SUBJECT: ISSUANCE OF AMENDMENT NO. 79 TO FACILITY OPERATING LICENSE
NO. NPF-29 - GRAND GULF NUCLEAR STATION, UNIT 1, REGARDING STANDBY
LIQUID CONTROL SYSTEM TECHNICAL SPECIFICATIONS (TAC NO. 73599)

SUBJECT: ISSUANCE OF AMENDMENT NO. 79 TO FACILITY OPERATING LICENSE
NO. NPF-29 - GRAND GULF NUCLEAR STATION, UNIT 1, REGARDING STANDBY
LIQUID CONTROL SYSTEM TECHNICAL SPECIFICATIONS (TAC NO. 73599)

ATTACHMENT TO LICENSE AMENDMENT NO. 79

SAFETY EVALUATION BY THE OFFICE OF NUCLEAR REACTOR REGULATION
RELATED TO AMENDMENT NO. 79 TO FACILITY OPERATING LICENSE NO. NPF-29

FIGURE 3.1.5-1

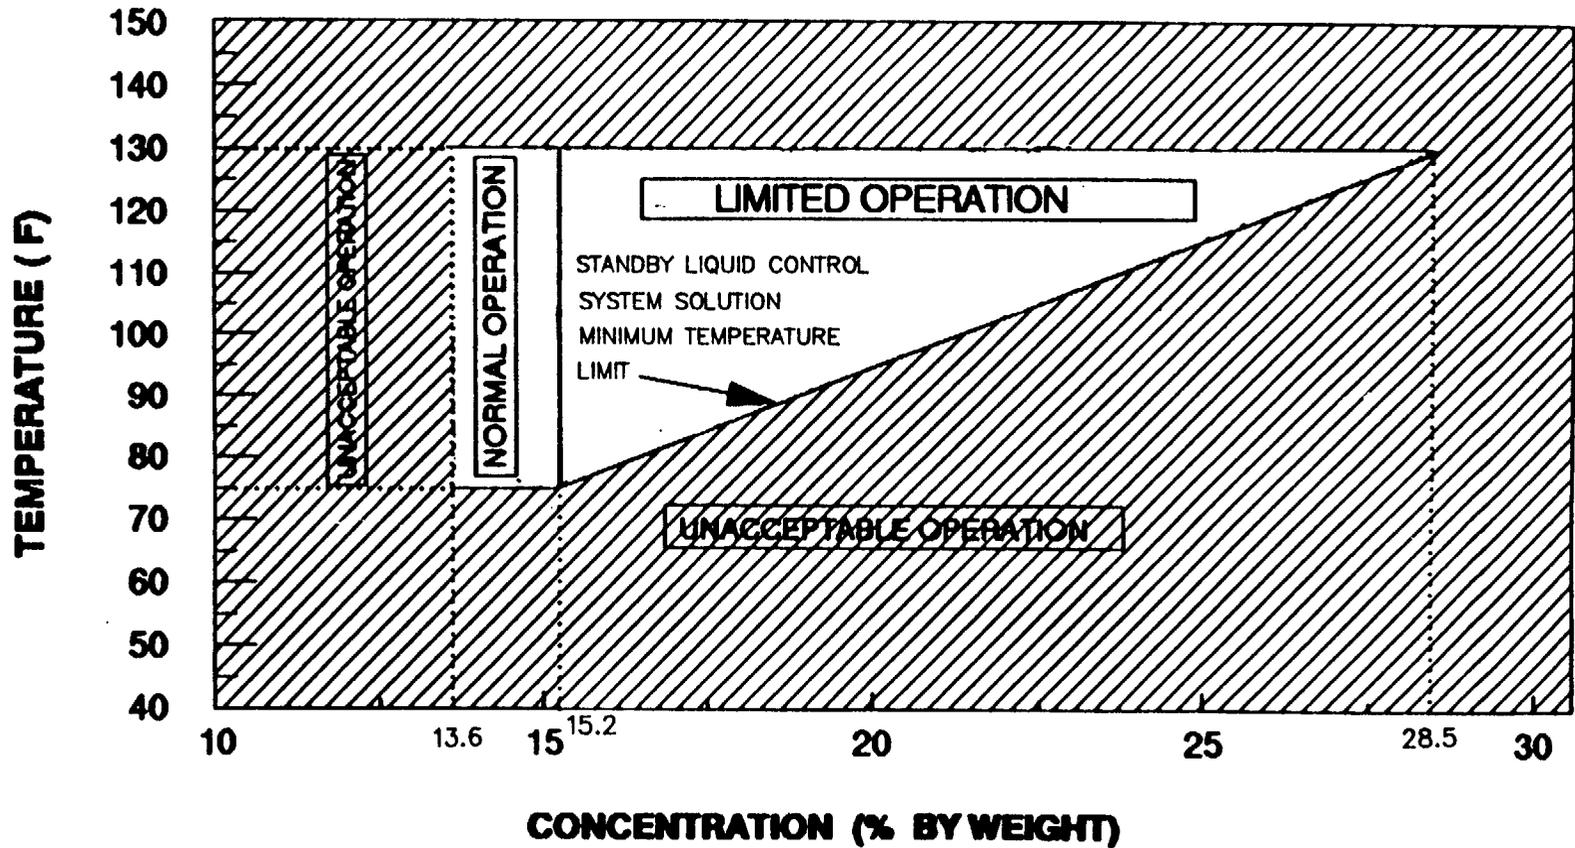
Temperature surveillance requirements are established on a frequency that assures a high probability that the solution temperature remains above the saturation temperature as illustrated by Figure 3.1.5-1. More frequent surveillance is required when operating in the "Limited Operation" region of Figure 3.1.5-1 because of decreased margin to saturation. Replacement of the explosive charges in the valves at regular intervals will assure that these valves will not fail because of deterioration of the charges.

The current TS specifies the minimum weight of sodium pentaborate of 5800 pounds to be maintained in the SLCS and requires the concentration of boron in solution to be within the limits of Figure 3.1.5-1, which defines the required concentrations of the sodium pentaborate solution (ranging from 13.6 percent to 28.5 percent by weight) as a function of temperature (varying from 67 to 130 °F). The existing TS requires the tank heaters and the heat tracing subsystem or the SLCS suction piping to be operable in order to maintain the higher concentrations of sodium pentaborate solution above its saturation temperature. This requirement precludes solution precipitation and thus avoids the potential for flow blockage in the SLCS. In order to reduce the need to actuate the tank heaters and the heat tracing subsystem, the licensee proposed to operate the plant at lower sodium pentaborate concentrations ranging from 13.6 percent to 15.2 percent for normal operations and only allow higher concentrations for up to 72 hours, if necessary, during addition of borax or dilution of the sodium pentaborate solution. To maintain the required minimum weight of sodium pentaborate of 5800 pounds in the solution, the licensee proposed in Figure 3.1.5-2 to specify the required solution volumes (ranging from 4281 to 5088 gallons) as a function of the solution concentrations (13.6 percent to 15.2 percent). The upper bound on solution concentration (15.2 percent) is established to assure that its corresponding saturation temperature of 70 °F is below the minimum allowable temperature of 75 °F for the solution in the SLCS. Since the containment ambient temperature is normally above 75 °F, tank heaters and heat tracing on suction piping will not normally need to be actuated.

FIGURE 3.1.5-2
SODIUM PENTABORATE SOLUTION CONCENTRATION/AVAILABLE VOLUME REQUIREMENTS

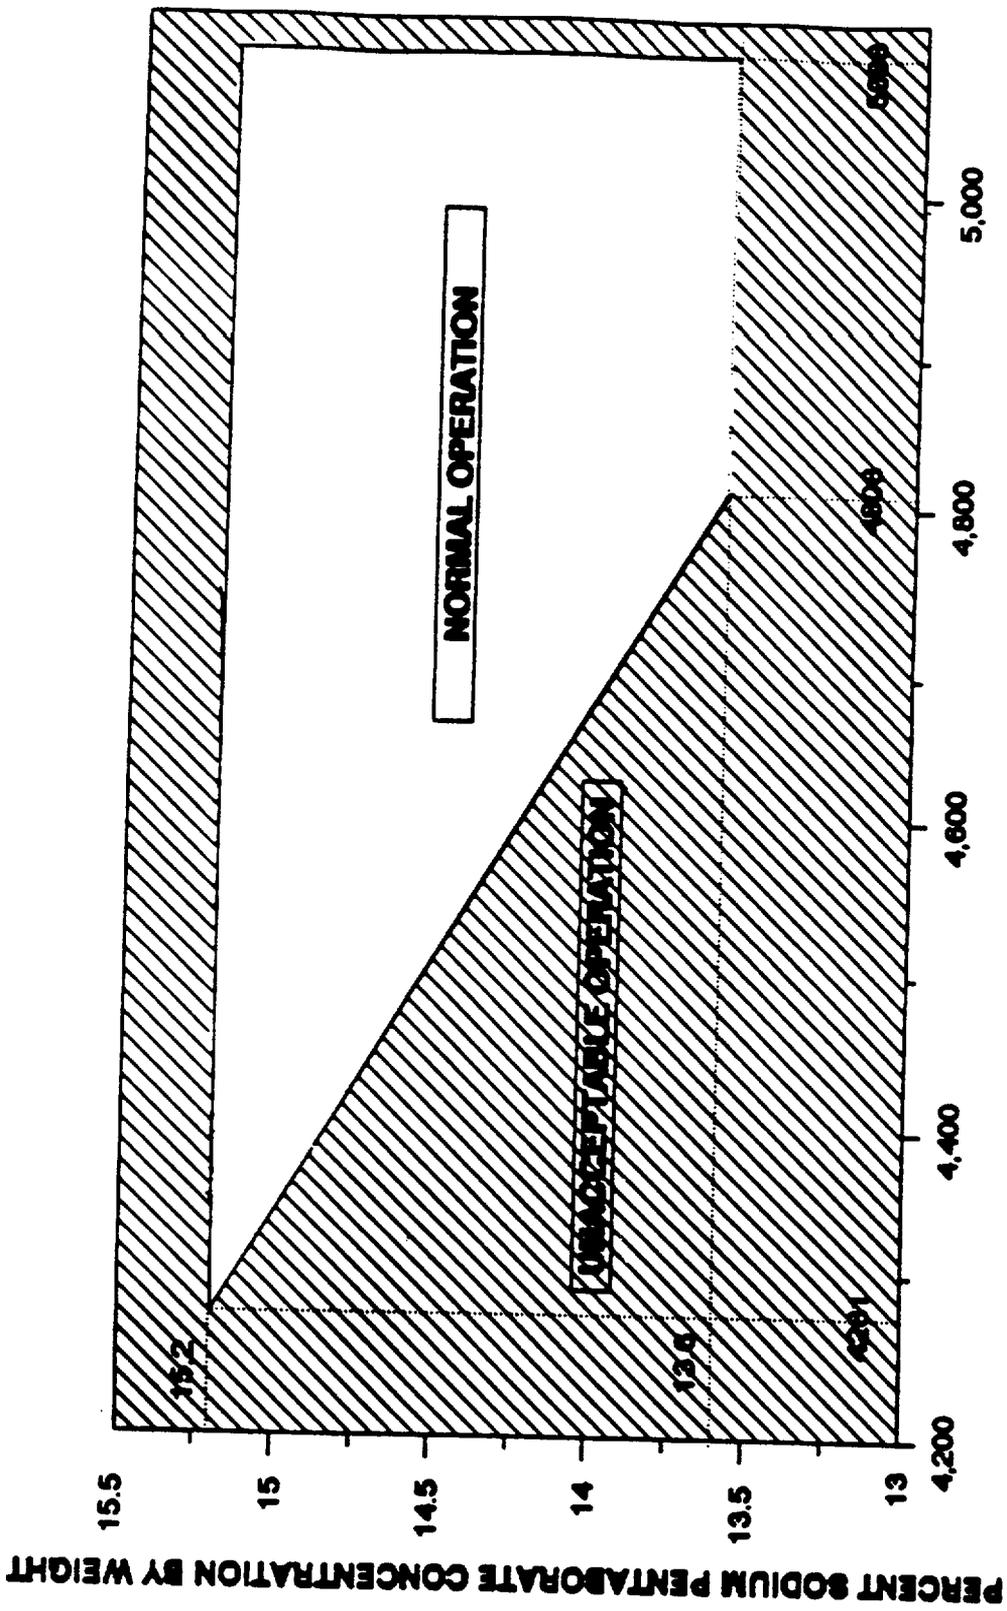
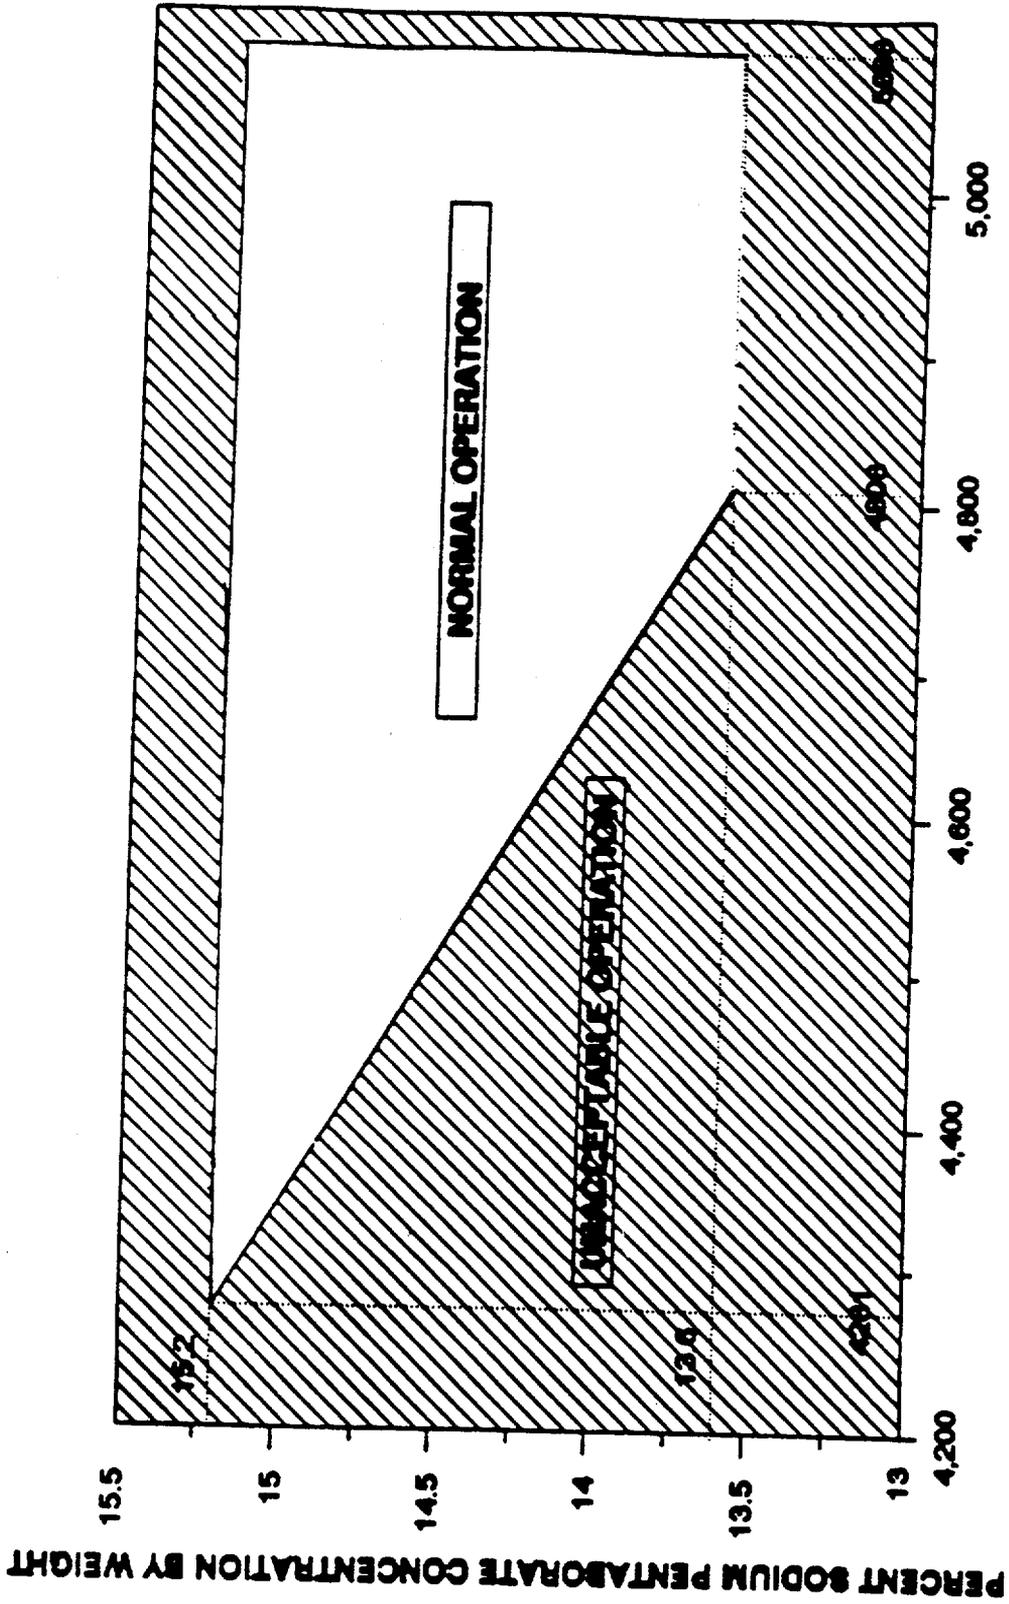
The licensee established the required volumes of the solution in proposed Figure 3.1.5-2 to assure that the solution will contain a weight of sodium pentaborate of 5800 pounds. This weight was previously approved by the NRC in the existing TS as the quantity of nuclear poison needed for cold shutdown margin during an ATWS event. The upper bound on the required volumes is limited by the tank volume of 5088 gallons.

- (1) Required Volume of the Solution - Figure 3.1.5-2, TS 4.1.5.a.1 and 4.1.5.a.2 Figure 3.1.5-2 is added for the required volume of the solution in the SLCS tank as a function of concentration of the sodium pentaborate solution. The surveillance requirements of volume and temperature limits for TS 4.1.5.a.1 and 4.1.5.a.2 are changed to be consistent with the limits specified in Figure 3.1.5-2. The staff finds that the proposed changes are consistent with the licensee's analytical results and in compliance with the requirements of the ATWS rule as specified in 10 CFR 50.62 and, therefore, concludes the changes are acceptable.
